END OF ADDENDUM No. 02

CCG Parry Sound

Job No. 13403

PARRYS OUND CANADIAN COAST GUARD BASE

SKE-201x01	
drawing no.	rev. no.

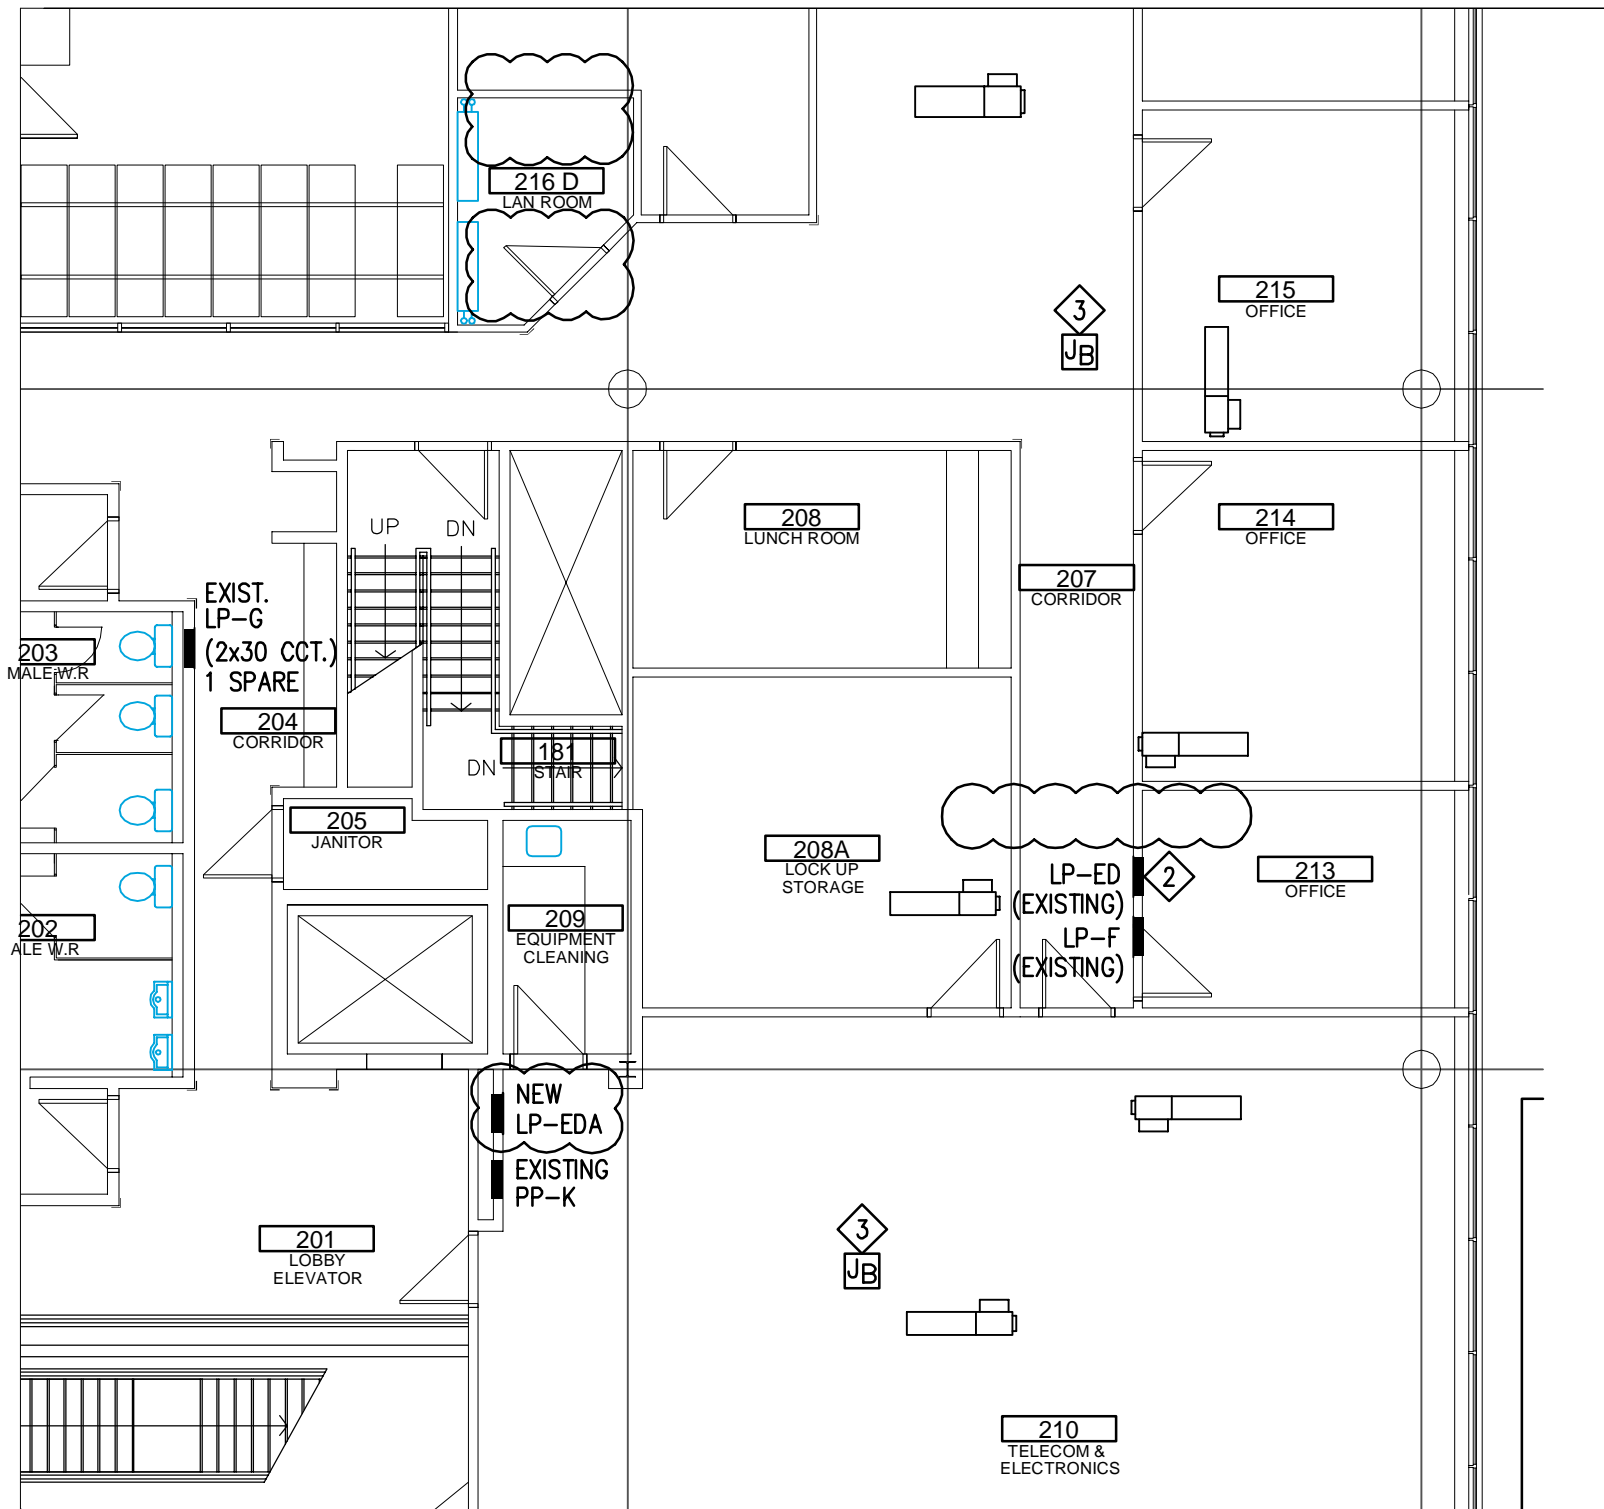
- .3 Refer to **Drawing E-201 – Main Building – Ground Floor Admin Wing Detail #1 (attached sketch SKE-201x01):**
 - .1 Revise location of new panel ‘LP-EDA’ from Corridor 207 to Telecom & Electronics Rm 210 adjacent to existing panel ‘PP-K’. Provide cutting, patching and finishing as required and include in the cost of the contract. Ensure there is enough clearance in front of the panelboard to meet code.

- .2 Delete FCU-02 and FCU-03 in LAN Rm 216D.
 - .3 Replace old pump P-08 in Fan Supply Room 182 with new and provide new starter, wiring and conduit to suit. Exact location to be coordinated on site.

- .4 Detail #1 / Drawing E-201: Revise diamond note #1 to read “Provide new starter, wiring and conduit to suit.”
- .4 Refer to **Drawing E-203 – Main Building Admin Wing Roof Plan:**
